RE: Response to Remaining Comment on Hydraulic Gradient for Irish Acres Subdivision Level I Nutrient-Pathogen Evaluation

RE: Response to 2nd Review of Irish Acres Subdivision Level I Nutrient-Pathogen Evaluation

RE: Response to Review of Irish Acres Subdivision Level I Nutrient-Pathogen Evaluation

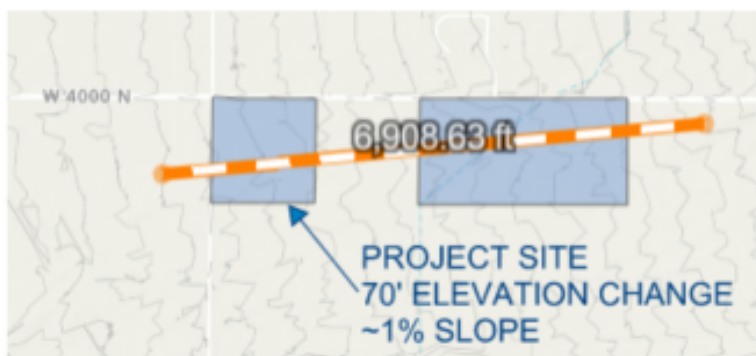
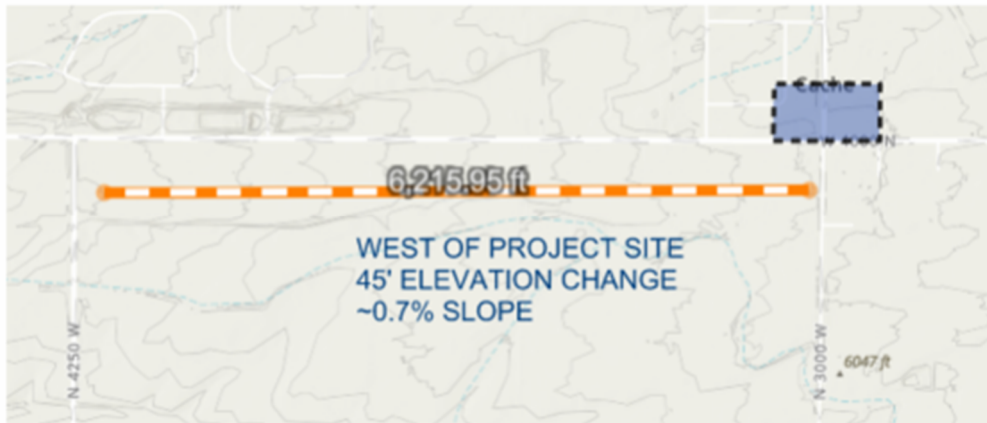
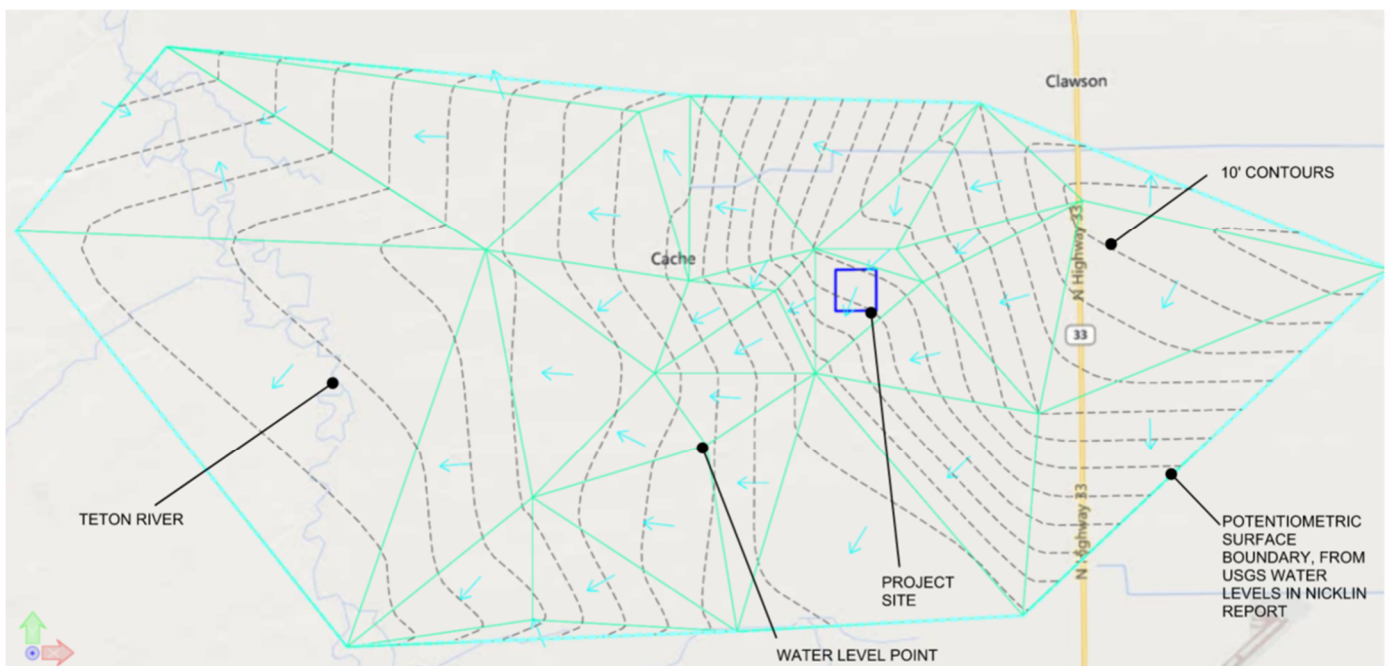
This letter is a follow up per our discussion on February 15, 2024. In that meeting, we left with one item needing further investigation for use in the mass-balance spreadsheets for the Level I study for Irish Acres. That item is the hydraulic gradient of the shallow aquifer of the site.

Taking this into account and our conversation on February 15th, we have taken the groundwater levels that were used in the report to set up a general area for study. We created a potentiometric map of the groundwater in the subdivision area. This map was to go as far west as the Teton River to see how groundwater levels are trending in that direction. Water levels were utilized from the Idaho Department of Water Resources (IDWR) well database.

It was found in this exercise that shallow groundwater levels very closely parallel the slope of the ground surface. This is to be expected and the topographic slope was used in the first iteration of the study. The shallow groundwater levels range from 10 to 20 feet below ground surface (bgs) in most areas. When a groundwater well is located adjacent to a surface water feature, the water level dropped below 10 feet to as shallow as 4 feet bgs. The following images from the Teton County GIS system with contours and measurements show the change in ground slope as we proceed west of the site toward the Teton River. At the project site the topographic slope is approximately 1%, which has been confirmed by our onsite survey. As we proceed about a mile west, the slope decreases to about 0.7%. The groundwater surface followed this same general trend but is sloping a little less steep than the ground and continues to get less steep the closer and closer we get to the River. One USGS well elevation was kept on the map from the Nicklin report, which is west of the river, and it shows that the groundwater slope likely changes direction at the River.

The results from the potentiometric mapping are shown below. Individual well points around the project site result in slopes varying from 0.8% to just shy of 2.0%. Averaging these slopes up and down gradient of the site result in a hydraulic gradient of 0.9%.

Y2 proposes to use a groundwater slope of 0.9% for the mass-balance spreadsheets. This results in a rise of 1.0 mg/L or less for lots and combinations of lots previously submitted in the study. If Harmony determines that this potentiometric mapping is insufficient, then it is recommended that the septic systems in the subdivision be designed with an Advantex wastewater system or some equivalent secondary standards treatment system.

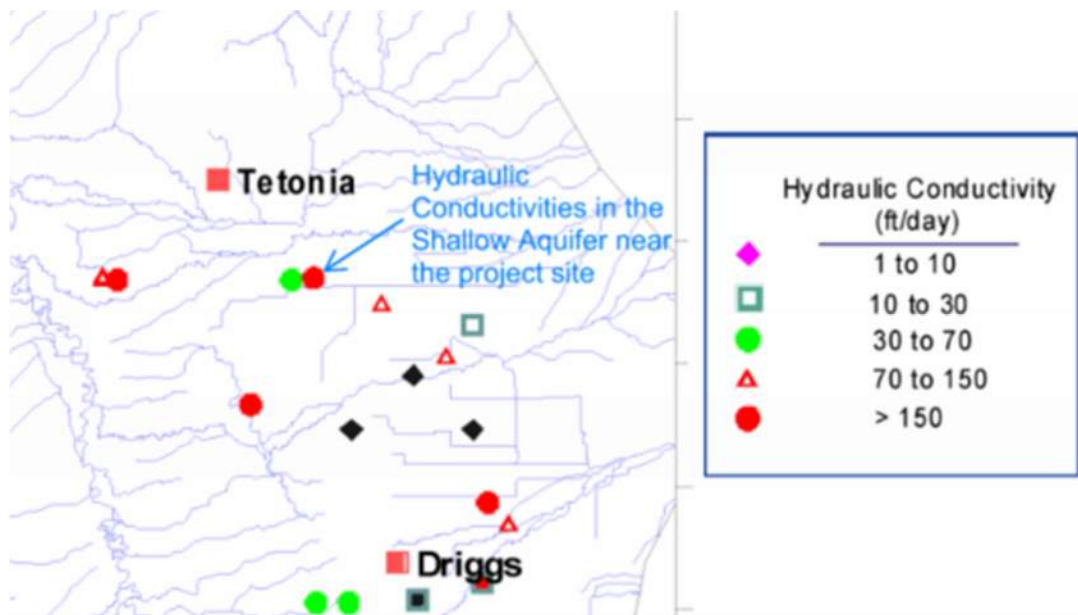
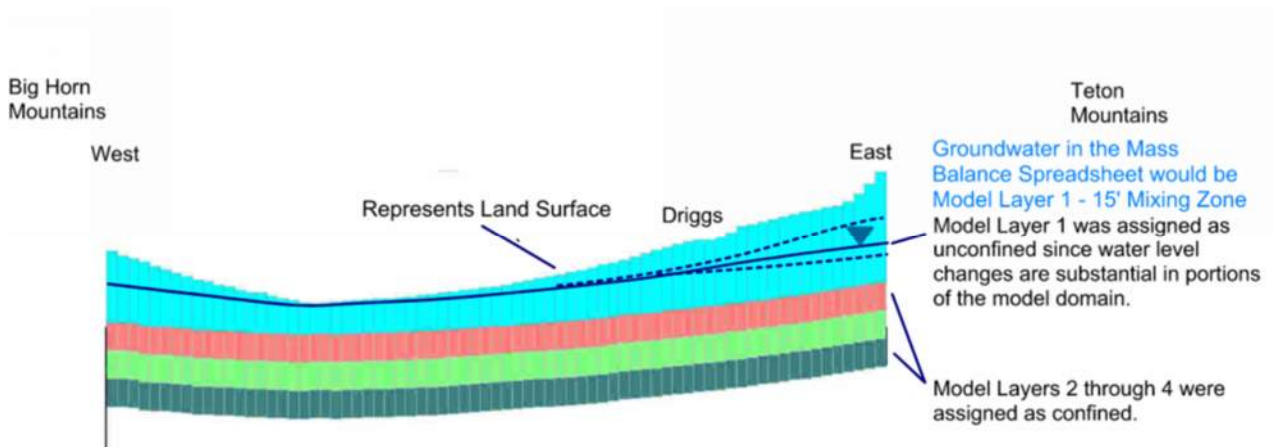
3. *Hydraulic Conductivity Estimate Above Reference Range:* The hydraulic conductivity used in all model simulations is 100 ft/day. Selection of this hydraulic conductivity value is not well supported. The author describes the 100ft/day value “conservative” for this use, noting that it is on the lower end of typical values for sand and gravel aquifers. The drilling logs cited and provided in the appendix make frequent mention of significant clay, which can greatly retard flow in porous media. There are several logs that have included pumping test data that could be used to infer a more supported hydraulic conductivity value. Evaluating this kind of existing data seems consistent with the Level I Nutrient-Pathogen criteria. Many of these rudimentary tests report production of 1 gallon per minute flow per foot of drawdown. While they lack rigorous description of methods or results, they should at least be compared with the assumed conductivity rate selected. The two best published estimates of conductivity covering this vicinity are from Nicklin (2003) and Cosgrove and Taylor (2007). Both of these assign values close to 25 ft/day for this location.

Three pump tests were found in the logs within ¼ mile of the project boundaries. The permit numbers for these wells are 702846, 702556 and 702847. Using the attached simplified hydraulic conductivity estimation

from Montana DEQ resulted in a range of hydraulic conductivities from 12 to 23 feet per day. As stated in the comment, the testing methods and results are not well documented. Also, the depth of pumping in these wells is much deeper than the mixing zone in the Nutrient Pathogen spreadsheet. There appear to be multiple layers in which hydraulic conductivity varies vertically. This is discussed further below in the review of the Nicklin report.

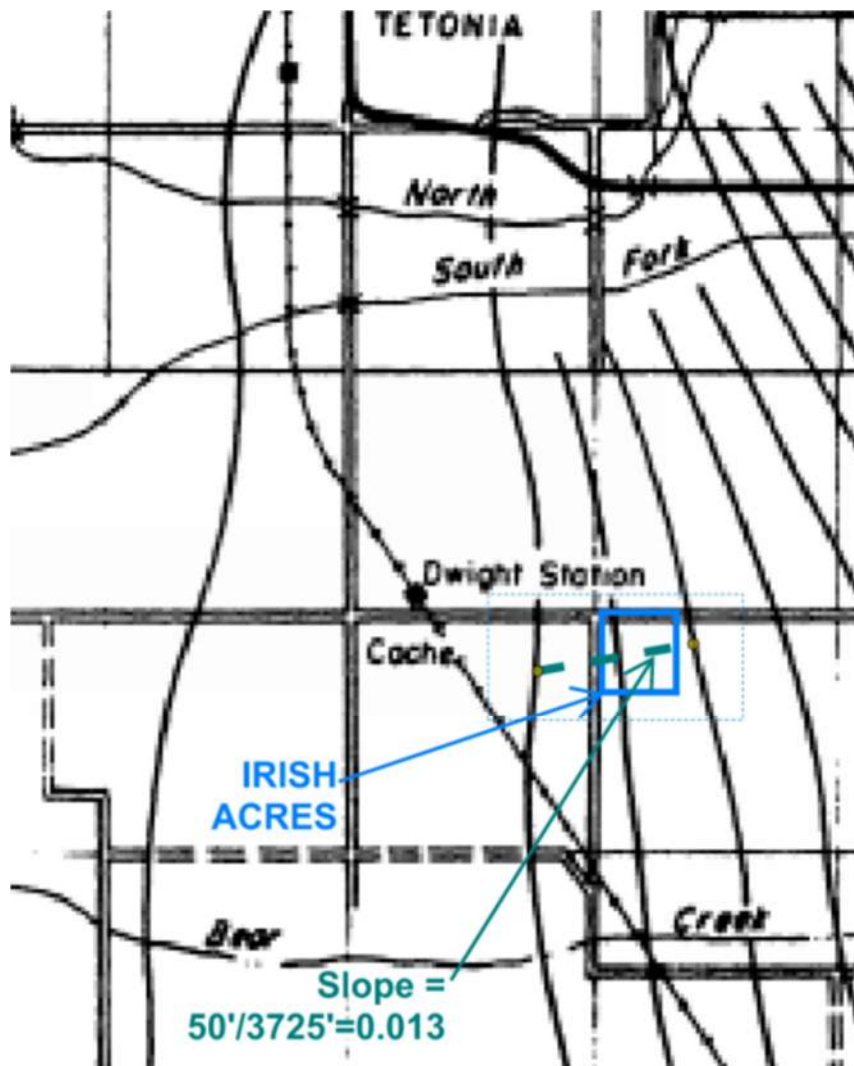
4. *Modeled Hydraulic Gradient Inconsistent with References:* The author assumes that the hydraulic gradient reflects the slope of the ground surface: 0.01 ft/ft. This generalized approximation seems a poor substitute for more specific references provided in mapping by Kilburn (1964), Nicklin (2003), and Cosgrove and Taylor (2007), which indicate that 0.006 is a representative value for this location. These maps do generally agree with the author’s assertion that the direction of groundwater flow is east to west.

Response – Nicklin (2003) states in section 4.1.6.3 that the hydraulic gradient assigned in their model ascertaining that the, “general flow direction is consistent with the land slope as typifies many basin aquifers”. Figure 22 of the report has the project area mapped with 50 feet of water level contours over 3,725 feet, or a slope of 0.013 ft/ft. This is consistent with the ground slope in the project area. The 0.013 ft/ft gradient as utilized in the updated Nutrient Pathogen Evaluation. Please see the excerpt below.
